BKU 98 1650' fsl, 760' fel Unit I, Sec. 19, T17S, R30E Eddy Co., NM API 30-015-21366 Plug and Abandonment Procedure 15 Apr 10

NMLC-028793A: Burch Keely Unit #98

API: 30-015-21366

RE: Plugging and Abandonment Procedure, Conditions of Approval

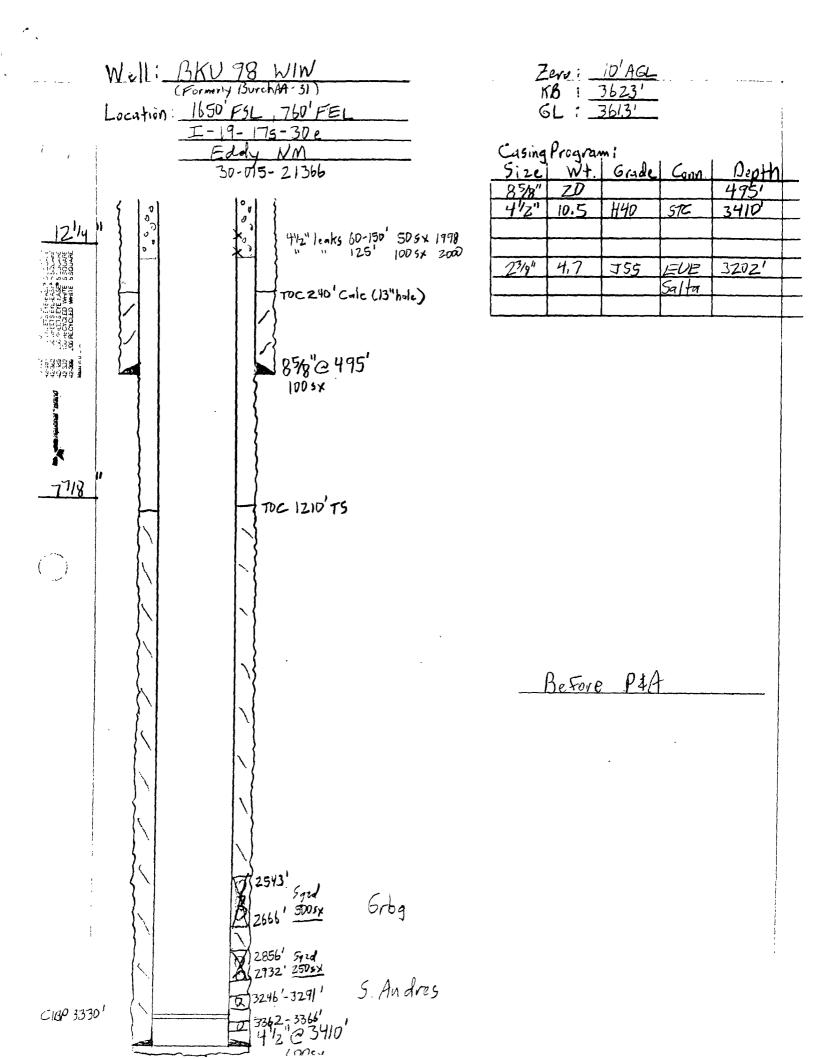
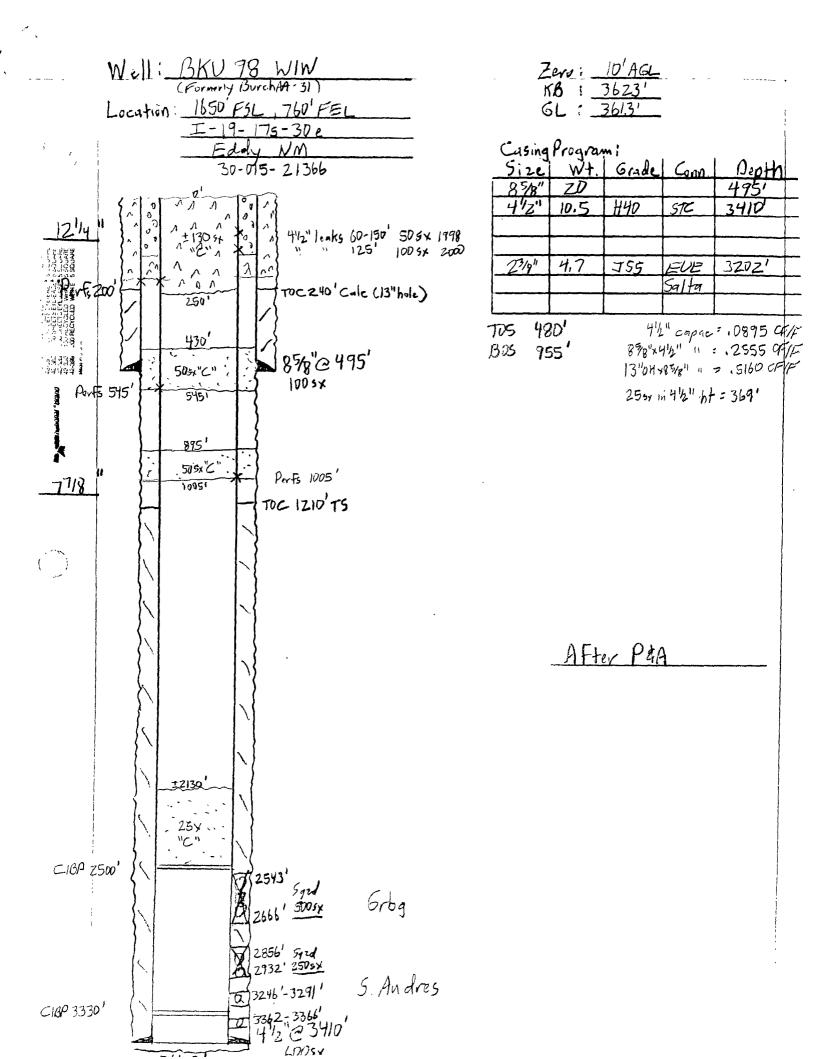
- 1. OK
- 2. OK
- 3. OK (Perfs)
- 4. OK (BOS)
- 5. OK (Casing shoe TOS)
- 6. Perforations needed Otherwise OK (Surface)
- 7. Verify cement to surface in all annuluses. Ground Level Dry Hole Marker required in this area Requirements attached.
- 8. OK
- 9. Submit subsequent report, with details.
